DVT Schematic & Layout Changing Request

Organization
R&D Lab. 2

Issued Date
2020.10.22

SoC Board

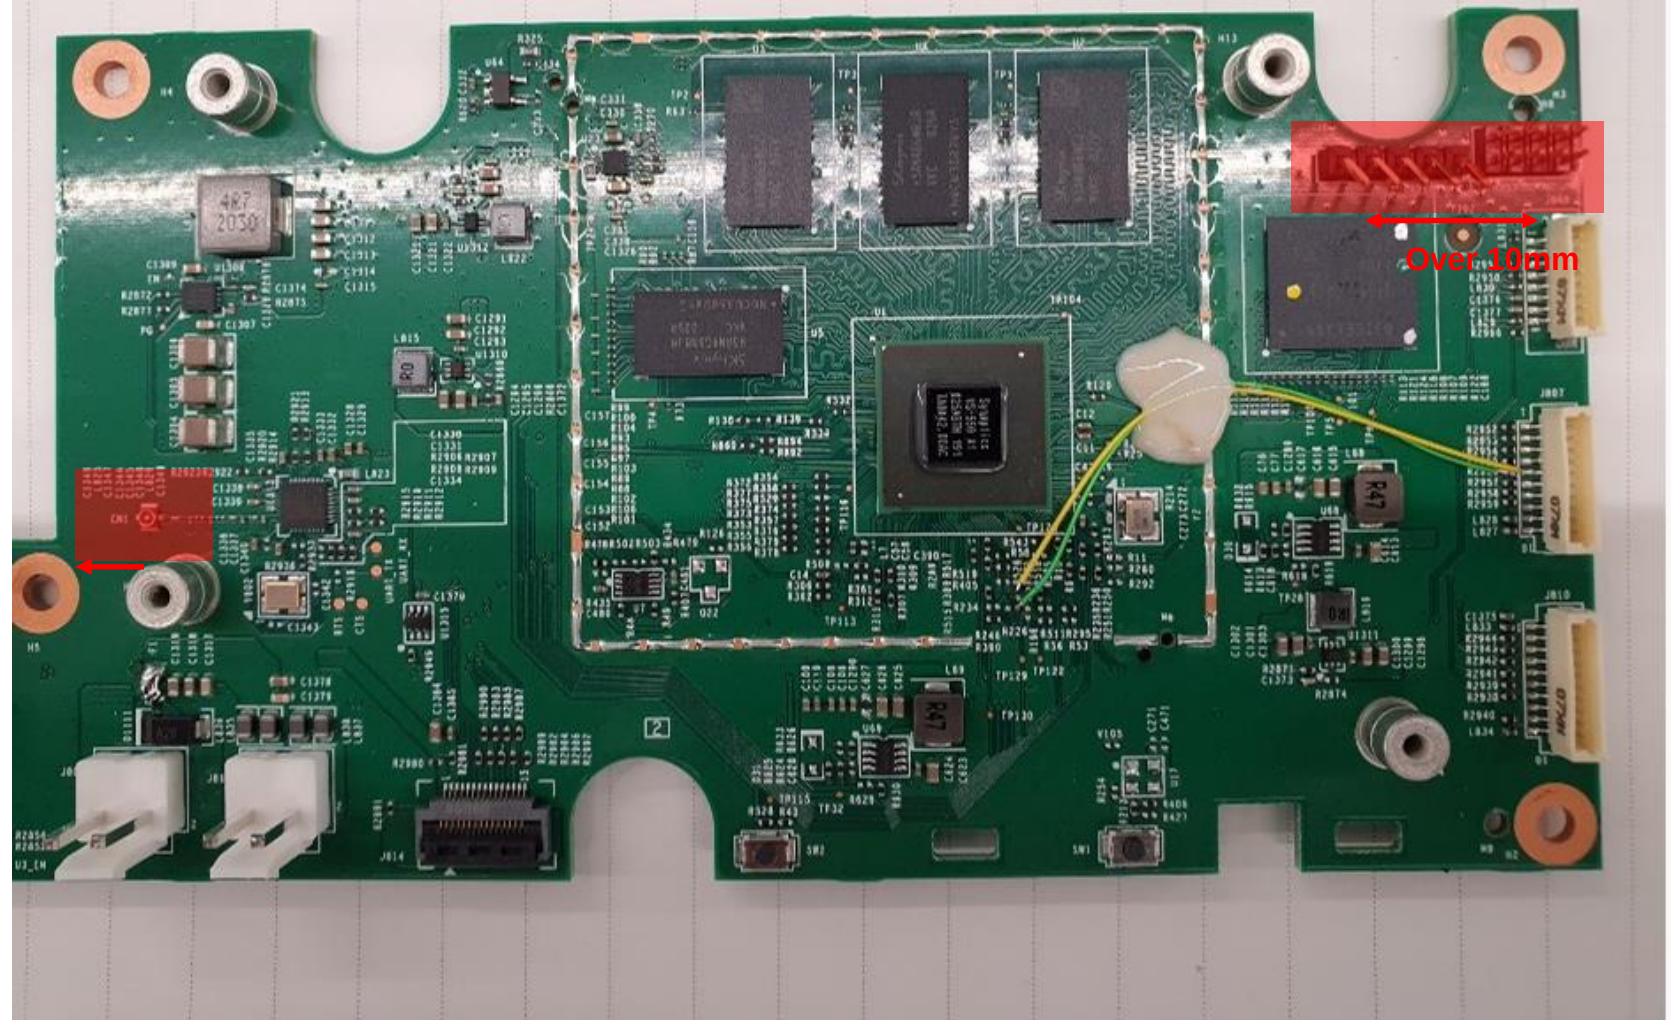
- **Add HW revision resistors(2 GPIO and pull-up/down resistors)**
- **Add circuit(components) for reduce DDR power noise(Synaptics recommend)**
- **Modify HDMI 4K 60frame**
- **Modify BT interface and add USB HUB**
- **Modify EVT rework points**
- **Add FET at 24V power line for reduce standby power consumption**

- **J4 and J6 distance : over 10mm**
 - Connector distance should be over 10mm.
- **CN1(BT connector)**
 - CN1 should be move left

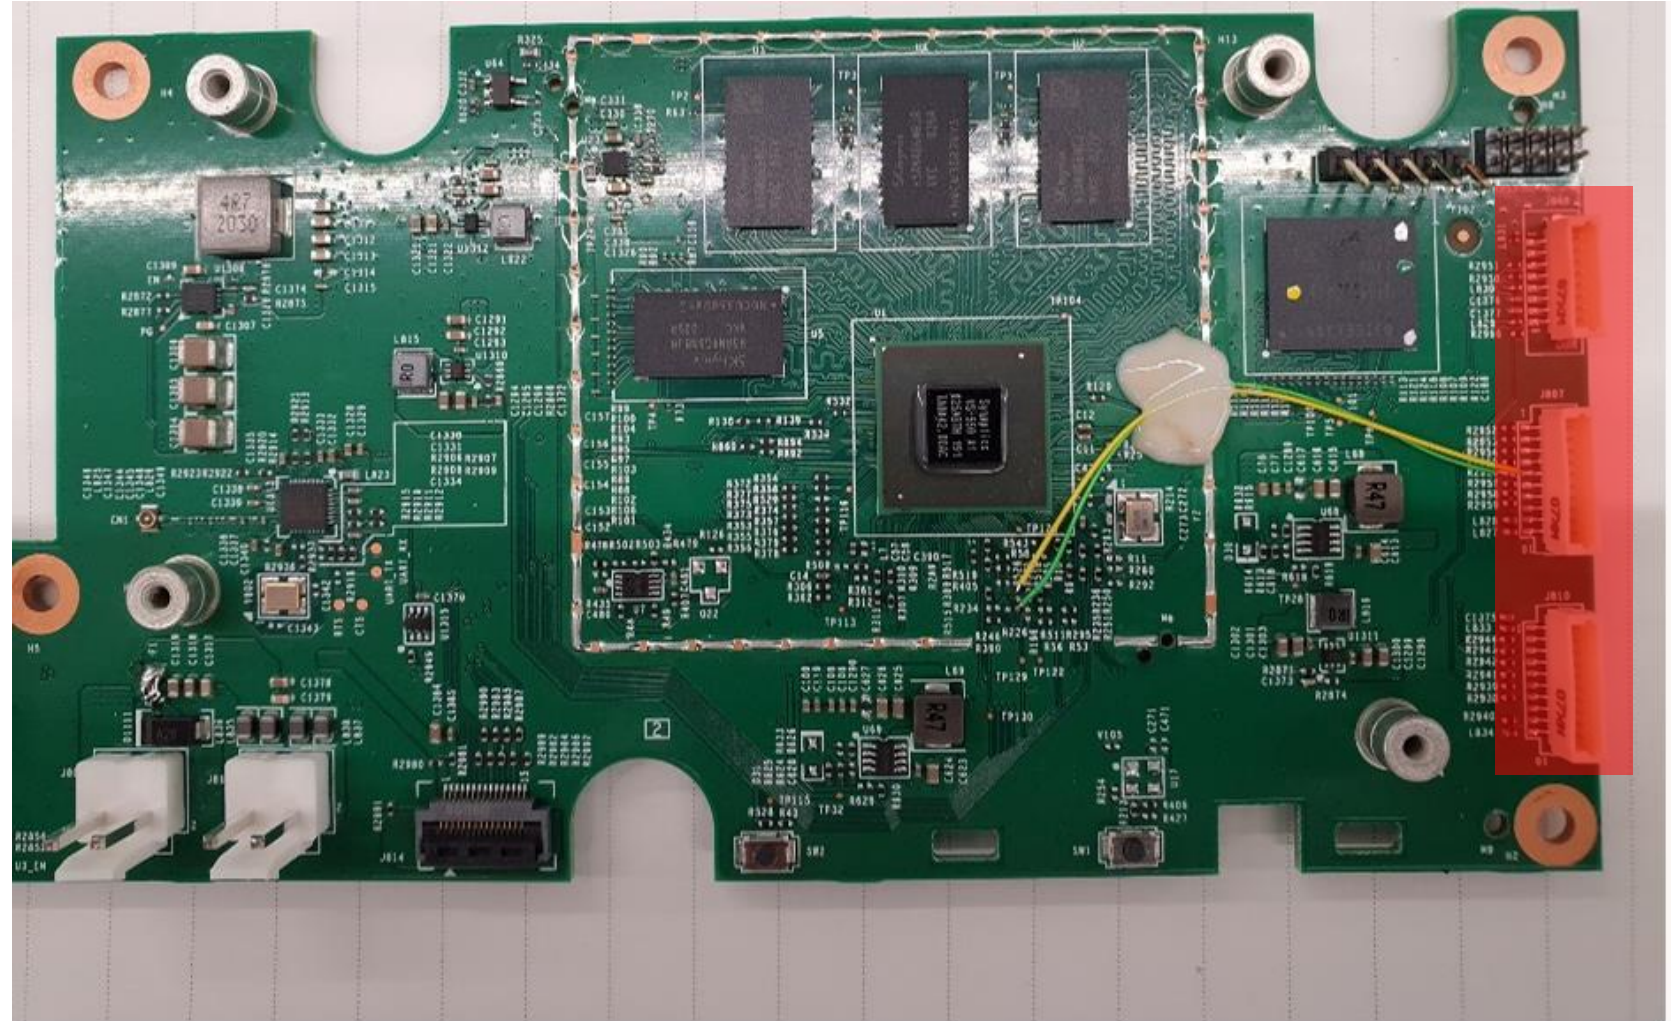
- J807, J808, J810 : Check possibility of change to FFC connectors?

Amp Board

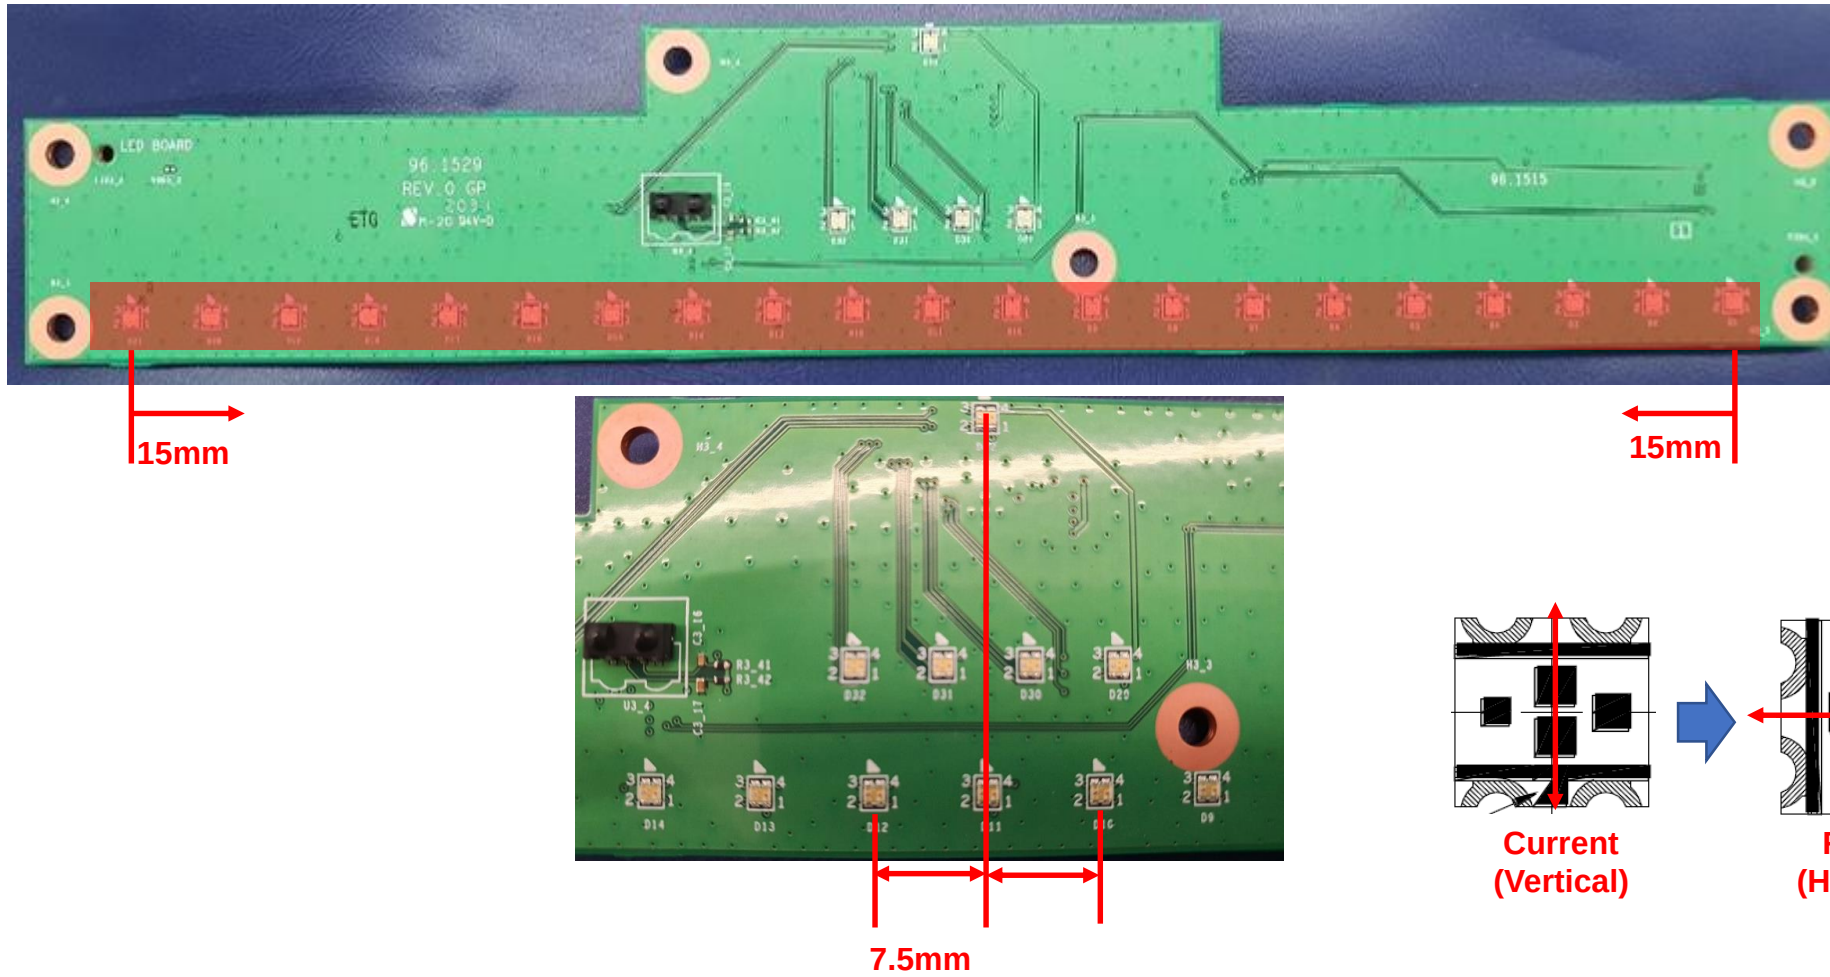
- **Connectors for Speaker**

- J802, J803, J804: Add to Silk Speaker name(Woofer/Left/Right)

- **Connectors moving from Top to Bottom layer**

- J802, J803, J804, J813: Location change Top to Bottom side to easy assembly

LED Board

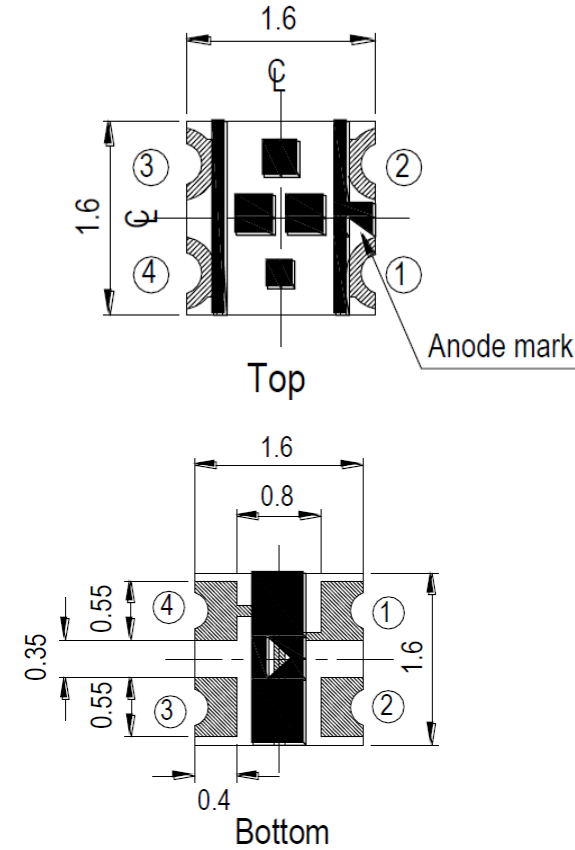
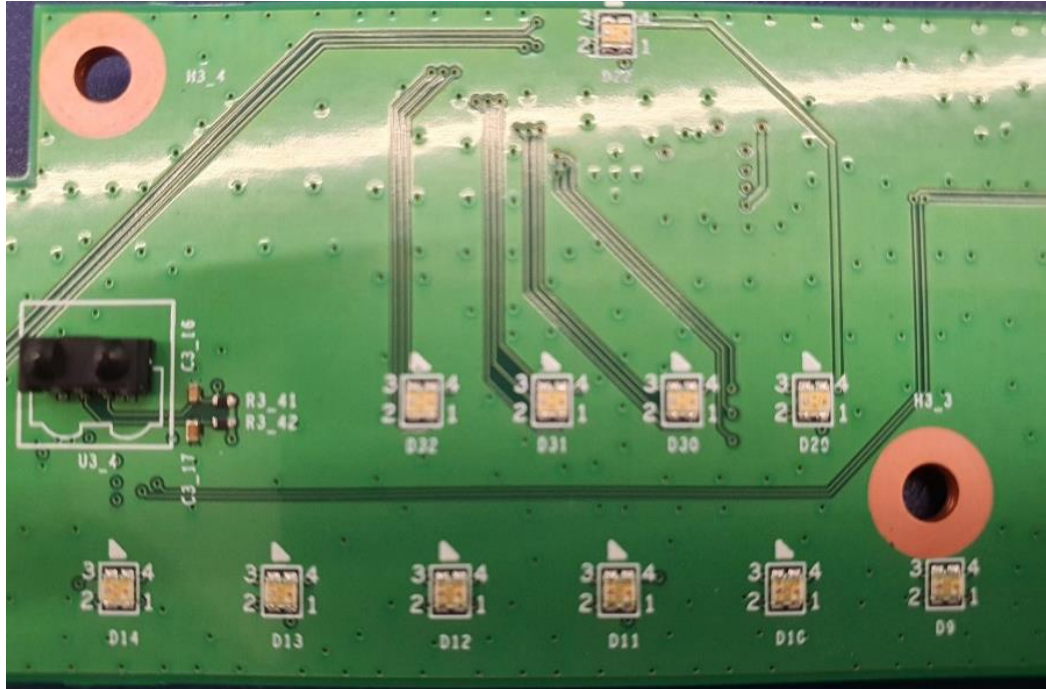
- LED distance from 9mm to 7.5mm(D1~D21) and Horizontal direction

- D1~D21: Distance(9mm → 7.5mm)
- D1~D21: Direction(Vertical → Horizontal)

- LED Pin silk need to be changed
 - Current silk referred from bottom view(change to top view)
